STARTER MOTOR IMPORTANT FITTING NOTICE

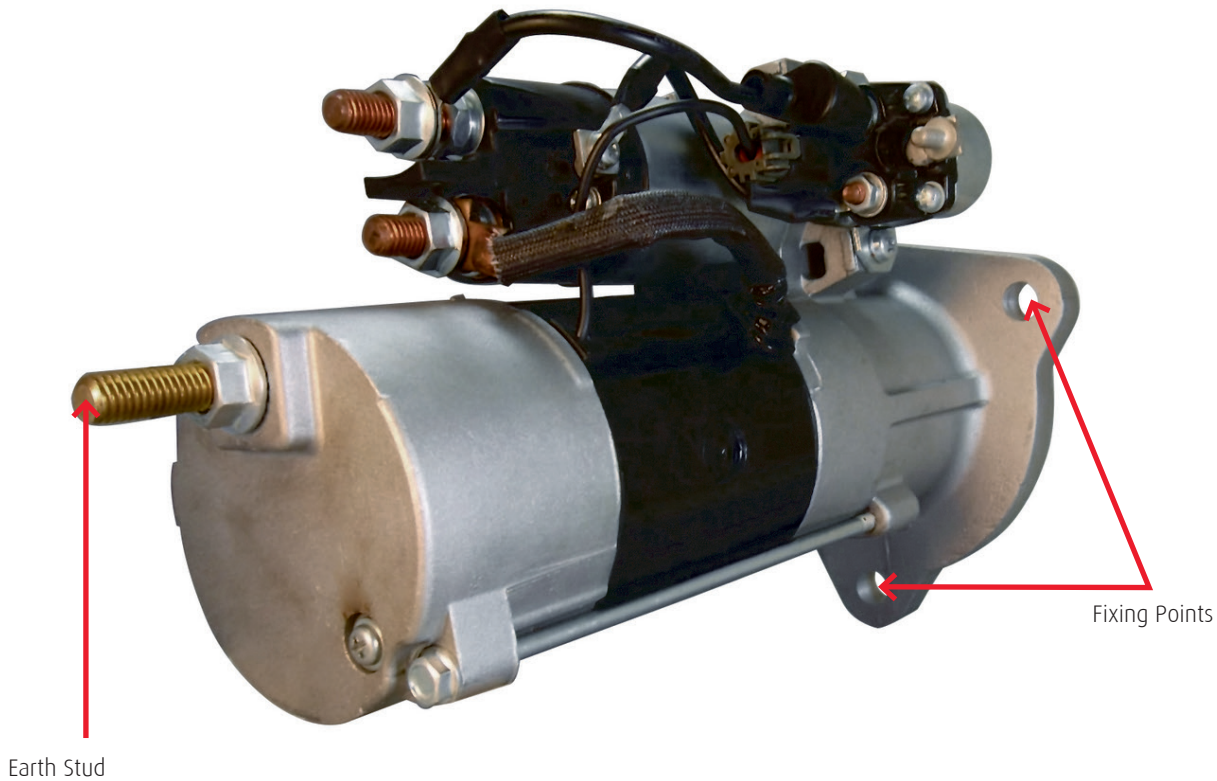
On some Volvo applications, for example the MD13 Euro 3 and Euro 5 engines have an engine earth strap fitted to the starter motor.

When replacing the starter motor with the VLST00010EM or VLST00020EM please fix the earth strap to one of the fixing points as shown in the illustration above.
